E3617A-03-S

S E R V I C E N O T E

E3617A Lab Bench DC Power Supply

POSSIBLE SHOCK HAZARD

**CAUTION: TEST FOR LOOSE AC MODULE**

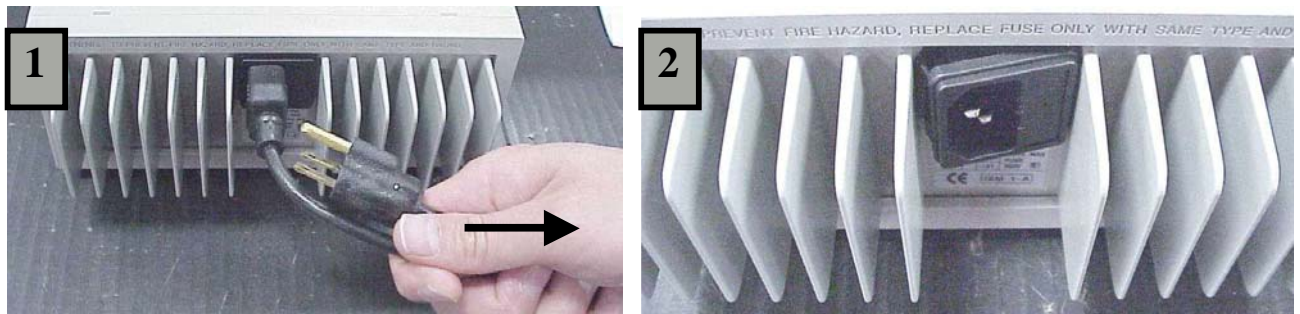
If the AC line cord is forcefully pulled in a side-to-side direction the AC Module can be pulled out of the rear heatsink, exposing the conductors that carry AC line voltage.

1. Make sure linecord is removed from outlet.
2. With linecord securely inserted in AC Module as shown, pull forcibly (2 times) in direction of arrow.

LOOSE AC MODULE

1. If the AC Module pulls out from Unit as shown it will need to be replaced.
2. If the AC Module remains in place it does not need to be changed. Put a mark on the AC input label in the lower left hand corner with indelible ink to indicate that the AC module has been checked. This label can be found below the AC module.

3**REMOVE COVER**

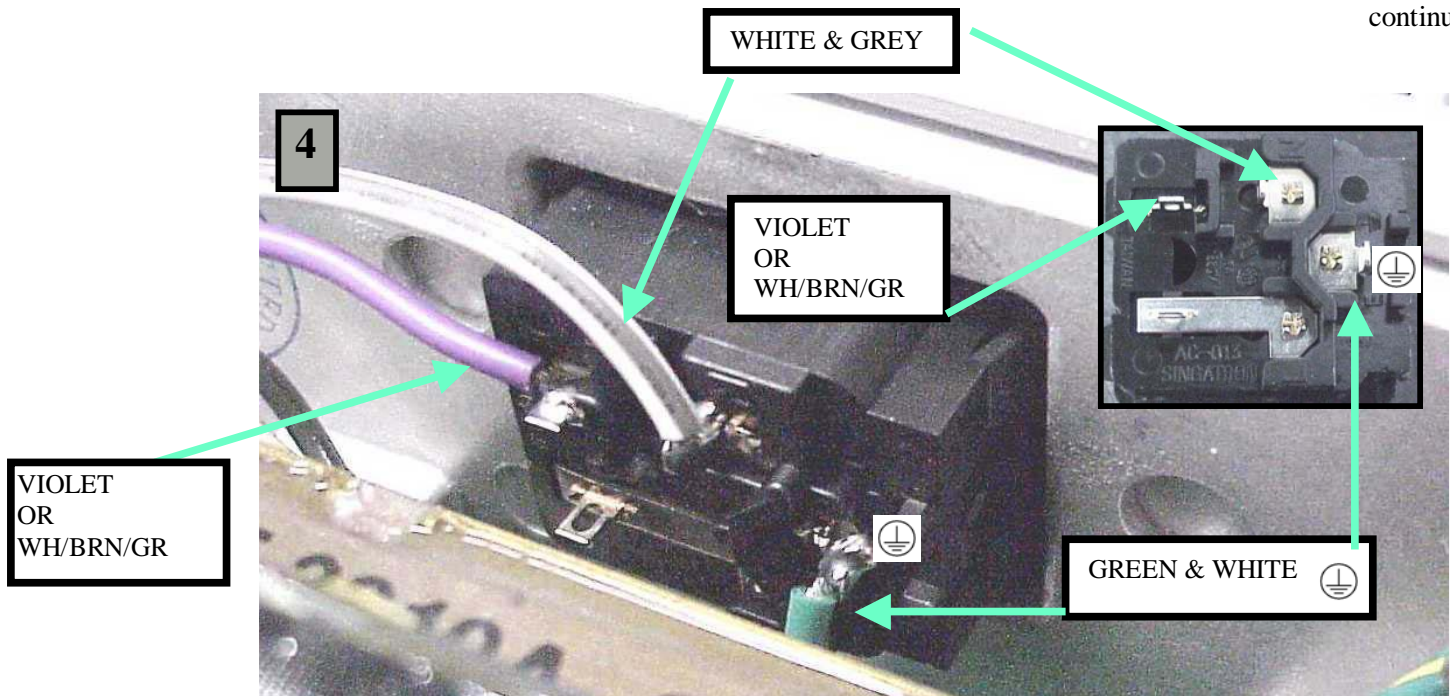
Pry Rear Bezel and Front Panel away from Cover in four places. Then lift Cover off unit.

Pry Tabs out on rear of Top Cover and lift Cover off of the unit

REPLACE MODULE with P/N 5065-6978. Before soldering perform “TEST FOR LOOSE AC MODULE” as shown in picture above. This will confirm that the new Module is secure. Solder wires and **REPLACE FUSE**.

100/120 VAC input-	use Fuse P/N 2110-0702 (2 amps, 250 volts)	E3610/11/12/14/15/16/17/20A
100/120 VAC input-	use Fuse P/N 2110-0918 (1.6 amps, 250 volts)	E3630A only
230 VAC input-	use Fuse P/N 2110-0599 (1 amp, 250 volts)	E3610/11/12/30A
230 VAC input-	use Fuse P/N 2110-1346 (1 amp, 250 volts)	E3614/15/16/17/20A

CAUTION: WIRING MUST BE CORRECT OR H_⊥ TSINK COULD BE AT LINE POTENTIAL.

CAUTION: MAKE SURE SAFETY GROUND IS ATTACHED TO HEATSINK
